Issue List

NCANG Repair Bldg 51 (Charlotte, NC)

Issue Name : EF-15 Not Operational

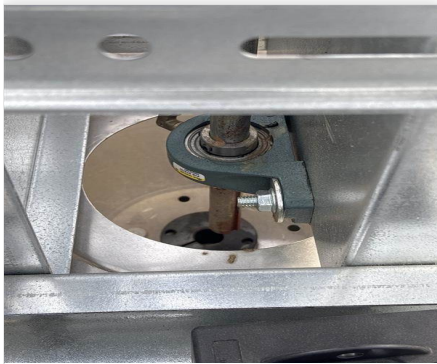
Description : EF-15 shaft to the blower is not connected at this time.

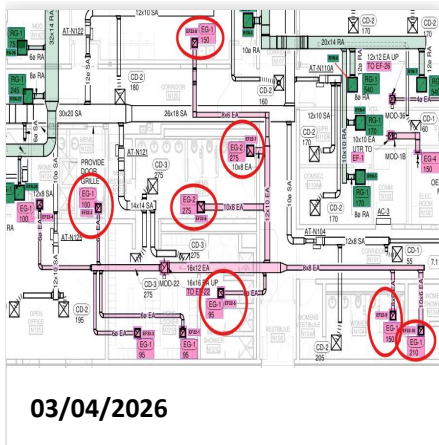
Issue Name : EF-22 Missing Dampers
Description : EF-22 is missing all dampers but 3 to TAB. The grilles with dampers are: EF22-1, EF22-3, and EF22-4. Recommended to install dampers with access due to the hard ceiling.
Created By : National TAB
Assigned To : National TAB - Antonio Flores-De La Cruz
Status : Open
Priority : Urgent
Asset Tag :
Originated Date : 03/03/2026 - Antonio Flores-De La Cruz - National TAB

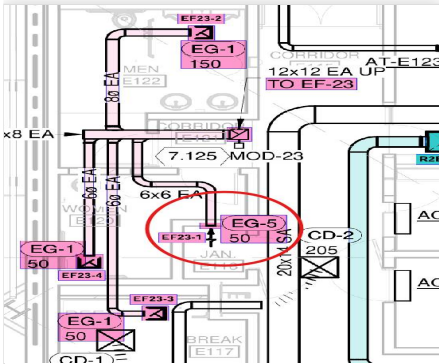
Issue Name : EF-23 High Flow
Description : EF-23 is 37% above design (407 CFM ACTUAL / 300 CFM DESIGN) and requires a sheave change to reduce flow. Motor sheave is on the lowest setting. Unable to balance due to a diffuser missing as well.
Created By : National TAB **Assigned To :** National TAB - Antonio Flores-De La Cruz
Status : Open
Priority : Urgent **Asset Tag :**
Originated Date : 02/12/2026 - Antonio Flores-De La Cruz - National TAB

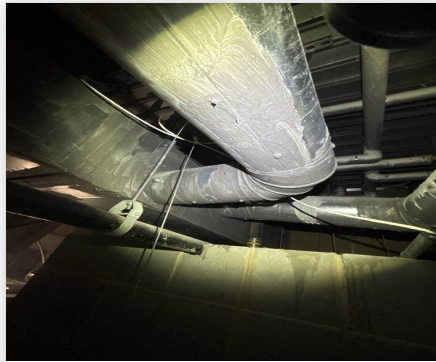
Issue Name : EF-23 Missing Grille
Description : Grille EF-23-1 in JANITORS E118 is not installed.
Created By : National TAB **Assigned To :** National TAB - Antonio Flores-De La Cruz
Status : Open
Priority : High **Asset Tag :**
Originated Date : 02/12/2026 - Antonio Flores-De La Cruz - National TAB

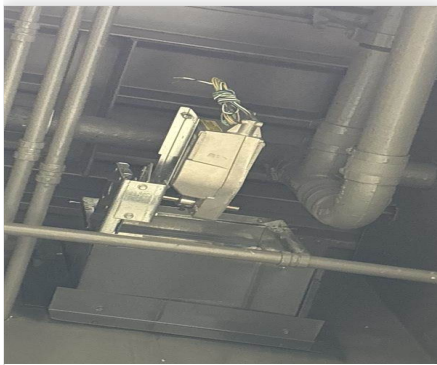
Issue Name : EF-26 Low Flow
Description : EF-26 is at 66% of design (99 CFM ACTUAL / 150 CFM DESIGN). The speed dial is at max. A possible cause could be a partially opened exhaust motorized damper. It was found that there is a damper at the takeoff and one at the arm of the equipment where the duct connects, which may add resistance to the system.

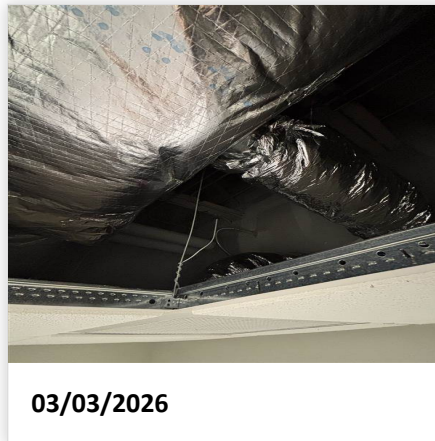
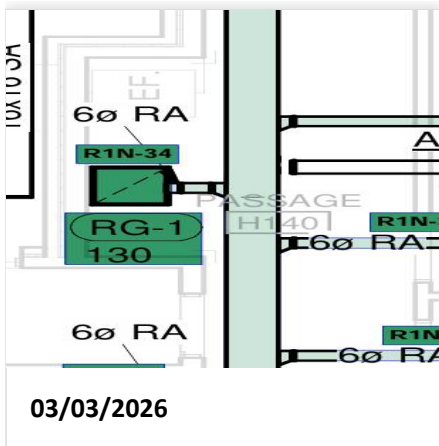
Issue Name : Hanger EFs Not Operational
Description : EF-9 through EF-19, EXCEPT EF-13, are not operational. Controls stated the exhaust fans might be wired incorrectly. Further investigation is required.
Created By : National TAB **Assigned To :** National TAB - Antonio Flores-De La Cruz
Status : Open
Priority : Urgent **Asset Tag :**
Originated Date : 02/12/2026 - Antonio Flores-De La Cruz - National TAB

- **03/05/2026 National TAB - Antonio Flores-De La Cruz**
 - MECHANICAL STATED ALL BUT EF-9, EF-14, AND EF-15 ARE OPERATIONAL NOW. WILL CHECK AND TAB

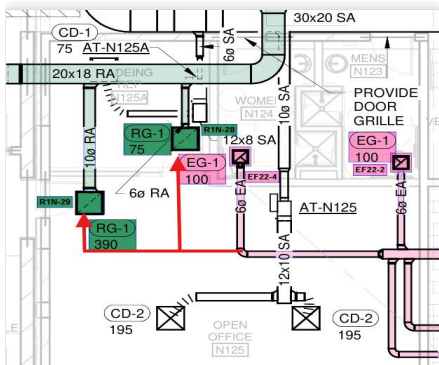
Issue Name : Incorrectly Installed Duct for Return
Description : Grilles R1N-28 and R1N-29 were attached to EF-22 ductwork.
Created By : National TAB **Assigned To :** National TAB - Antonio Flores-De La Cruz
Status : Open
Priority : **Urgent** **Asset Tag :**
Originated Date : 03/03/2026 - Antonio Flores-De La Cruz - National TAB

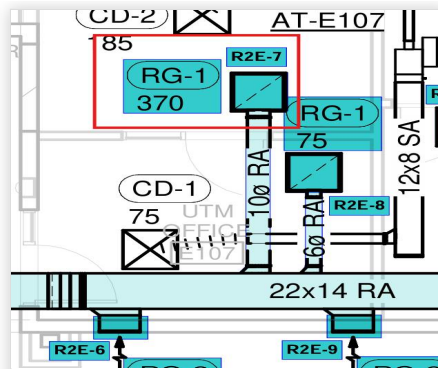
Issue Name : Missing Damper for Return Grille
Description : Return Grille R2E-7 in E107A is missing the damper to balance.
Created By : National TAB **Assigned To :** National TAB - Antonio Flores-De La Cruz
Status : Open
Priority : Urgent **Asset Tag :**
Originated Date : 03/02/2026 - Antonio Flores-De La Cruz - National TAB

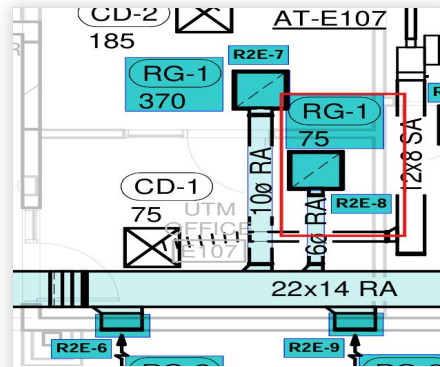
Issue Name : Missing Damper for Return Grille in E107
Description : Grille R2E-8 is missing the damper to balance.
Created By : National TAB **Assigned To :** National TAB - Antonio Flores-De La Cruz
Status : Open
Priority : Urgent **Asset Tag :**
Originated Date : 03/02/2026 - Antonio Flores-De La Cruz - National TAB

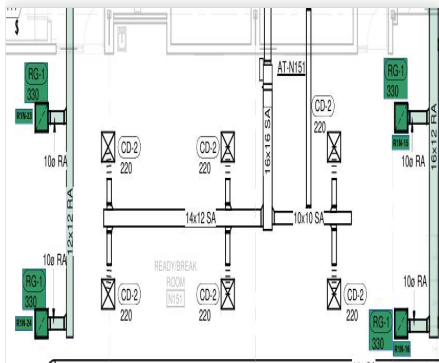
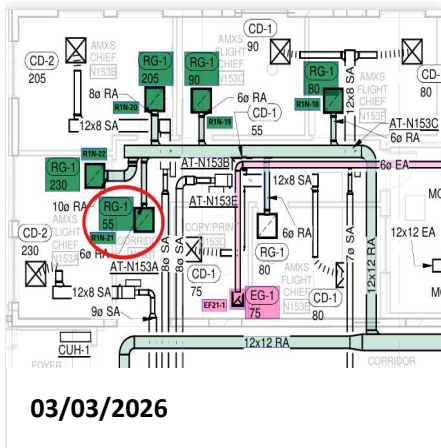
Issue Name : Missing Multiple Return Dampers in ROOM READY/BREAKROOM N151
Description : Return grilles: R1N-15, R1N-16, R1N-23, and R1N-24 are all missing dampers to TAB.

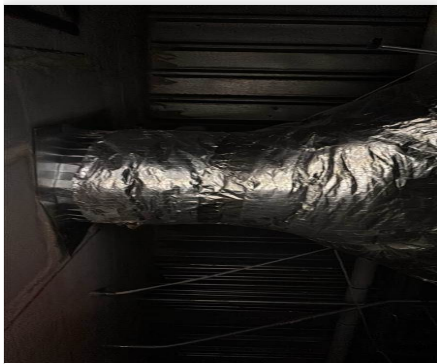
Issue Name : Missing Return Damper in OPEN OFFICE E123
Description : Damper for Grille R2E-15 is missing to balance.
Created By : National TAB **Assigned To :** National TAB - Antonio Flores-De La Cruz
Status : Open
Priority : Urgent **Asset Tag :**
Originated Date : 03/02/2026 - Antonio Flores-De La Cruz - National TAB

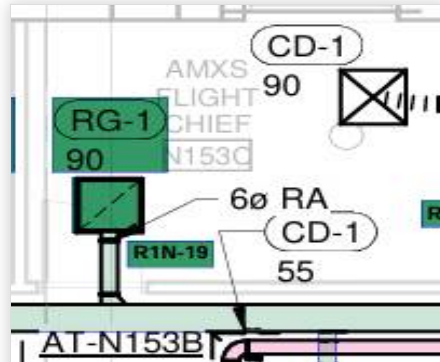
Issue Name : Missing Return Damper in ROOM AMXS FLIGHT CHIEF N153C
Description : Grille R1N-19 is missing the damper to TAB.
Created By : National TAB **Assigned To :** National TAB - Antonio Flores-De La Cruz
Status : Open
Priority : Urgent **Asset Tag :**
Originated Date : 03/03/2026 - Antonio Flores-De La Cruz - National TAB

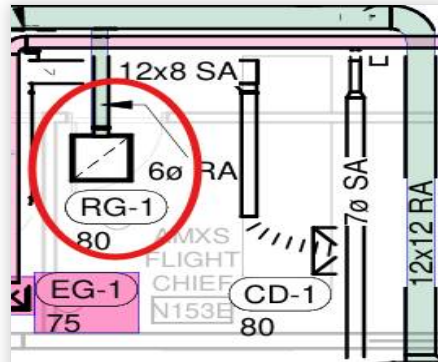
Issue Name : Missing Return Damper in ROOM AMXS FLIGHT CHIEF N153E
Description : Grille in ROOM AMXS FLIGHT CHIEF N153E is missing the damper to TAB.
Created By : National TAB **Assigned To :** National TAB - Antonio Flores-De La Cruz
Status : Open
Priority : Urgent **Asset Tag :**
Originated Date : 03/03/2026 - Antonio Flores-De La Cruz - National TAB

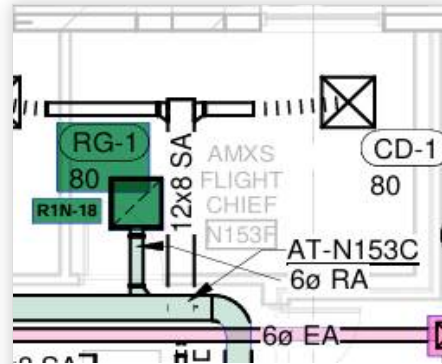
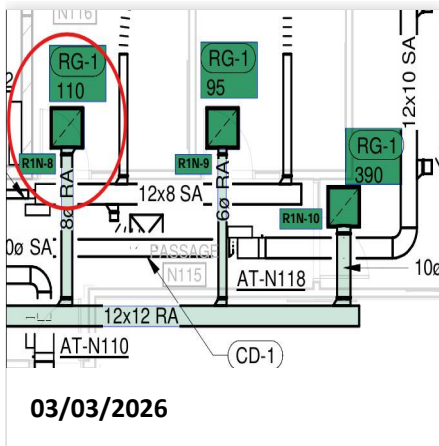
Issue Name : Missing Return Damper in ROOM AMXS FLIGHT CHIEF N153F
Description : Grille R1N-18 is missing the damper to TAB.
Created By : National TAB **Assigned To :** National TAB - Antonio Flores-De La Cruz
Status : Open
Priority : Urgent **Asset Tag :**
Originated Date : 03/03/2026 - Antonio Flores-De La Cruz - National TAB

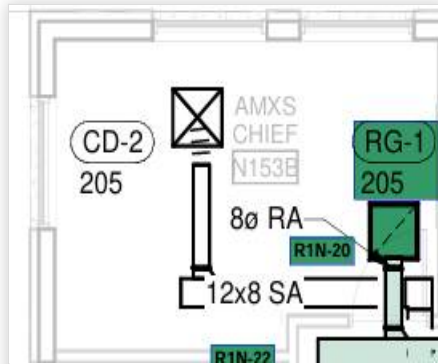
Issue Name : Missing Return Damper in ROOM AXMS CHIEF N153B
Description : Grille R1N-20 is missing the damper to TAB.
Created By : National TAB **Assigned To :** National TAB - Antonio Flores-De La Cruz
Status : Open
Priority : Urgent **Asset Tag :**
Originated Date : 03/03/2026 - Antonio Flores-De La Cruz - National TAB

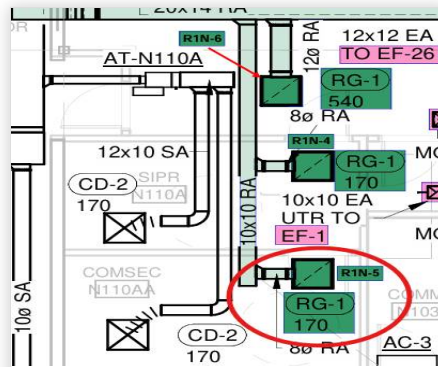
Issue Name : Missing Return Damper in ROOM COMSEC N110AA
Description : Grille R1N-5 is missing the damper to TAB.
Created By : National TAB **Assigned To :** National TAB - Antonio Flores-De La Cruz
Status : Open
Priority : Urgent **Asset Tag :**
Originated Date : 03/03/2026 - Antonio Flores-De La Cruz - National TAB

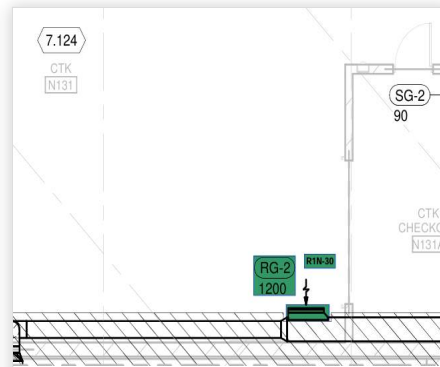
Issue Name : Missing Return Damper in ROOM CTK N131
Description : Grille R1N-30 is missing the damper to TAB.
Created By : National TAB **Assigned To :** National TAB - Antonio Flores-De La Cruz
Status : Open
Priority : Urgent **Asset Tag :**
Originated Date : 03/03/2026 - Antonio Flores-De La Cruz - National TAB

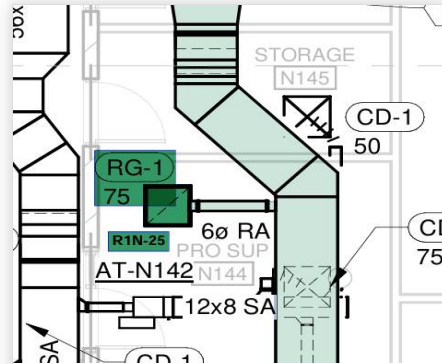
Issue Name : Missing Return Damper in Room PRO SUP N144
Description : Return Damper for Grille R1N-45 is missing to TAB.
Created By : National TAB **Assigned To :** National TAB - Antonio Flores-De La Cruz
Status : Open
Priority : Urgent **Asset Tag :**
Originated Date : 03/03/2026 - Antonio Flores-De La Cruz - National TAB

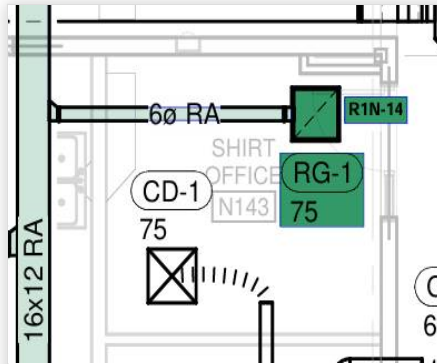
Issue Name : Missing Return Damper in ROOM SHIRT OFFICE N143
Description : Grille R1N-14 is missing the return damper to TAB.
Created By : National TAB **Assigned To :** National TAB - Antonio Flores-De La Cruz
Status : Open
Priority : Urgent **Asset Tag :**
Originated Date : 03/03/2026 - Antonio Flores-De La Cruz - National TAB

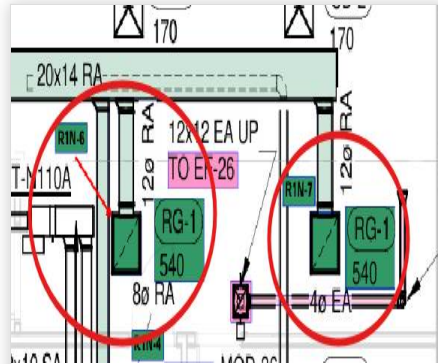
Issue Name : Missing Return Dampers in ROOM AVIONICS N110
Description : Grilles R1N-6 and R1N-7 are missing the dampers to TAB.
Created By : National TAB **Assigned To :** National TAB - Antonio Flores-De La Cruz
Status : Open
Priority : Urgent **Asset Tag :**
Originated Date : 03/03/2026 - Antonio Flores-De La Cruz - National TAB

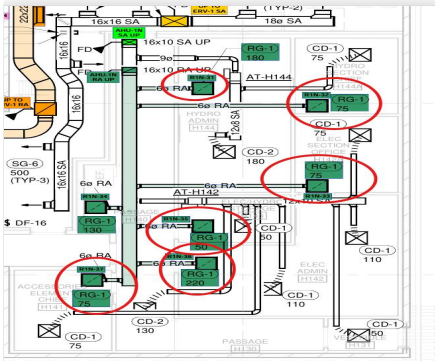
Issue Name : Multiple Dampers Missing HANGER SHOP NORTH
Description : Return Grilles R1N-31 through R1N-37, EXCEPT R1N-34, are missing dampers to balance the return.
Created By : National TAB **Assigned To :** National TAB - Antonio Flores-De La Cruz
Status : Open
Priority : Urgent **Asset Tag :**
Originated Date : 03/03/2026 - Antonio Flores-De La Cruz - National TAB

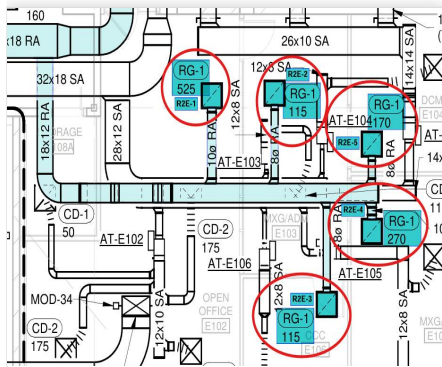
Issue Name : Multiple Return Dampers missing
Description : Dampers for Return Grilles: RE2-1 through RE2-5 are missing to balance.
Created By : National TAB
Assigned To : National TAB - Antonio Flores-De La Cruz
Status : Open
Priority : Urgent
Asset Tag :
Originated Date : 03/02/2026 - Antonio Flores-De La Cruz - National TAB

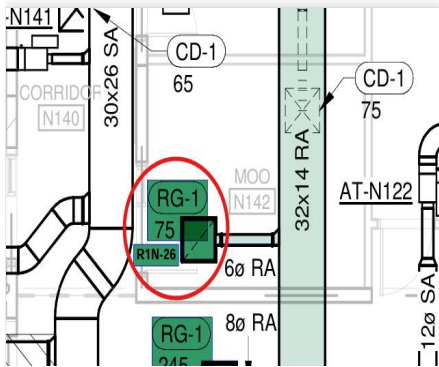
Issue Name : Return Damper Missing in ROOM MOO 142
Description : Return Grille R1N-26 is missing the damper to TAB.
Created By : National TAB **Assigned To :** National TAB - Antonio Flores-De La Cruz
Status : Open
Priority : **Urgent** **Asset Tag :**
Originated Date : 03/03/2026 - Antonio Flores-De La Cruz - National TAB
